[REDACTED]  
**Date:** 19<sup>th</sup> August 2022  
**Your Ref:** 2022/2885/P  
**Our Ref:** 161

**PLANNING APPLICATION REFERENCE 2022/2885/P 37C FITZJOHN'S AVENUE, LONDON, CAMDEN, NW3 5JY**

**Photograph 1: Taken from 37b third floor balcony showing the existing gap between 37c and 37b**

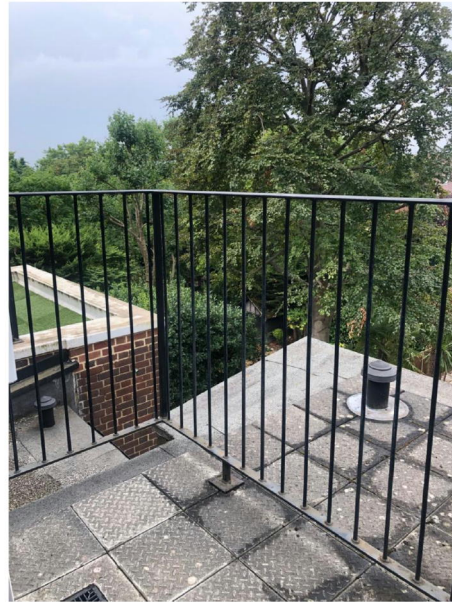
In terms of the detailed design, the application proposal would include a terrace at third floor level, abutting the terrace at 37b Fitzjohn's Avenue. At present there is a gap between the properties either side of 37b, as evidence by photographs 1 – 3 below. However, the application proposes to infill this gap resulting in the balconies sitting side by side. This would alter the original form of the house as well as impact the residential amenity enjoyed at the existing balcony at 37b which would be considered contrary to Policy A1 and D1. It is requested that the applicant provides further details concerning the privacy protection measures proposed between the two balconies.
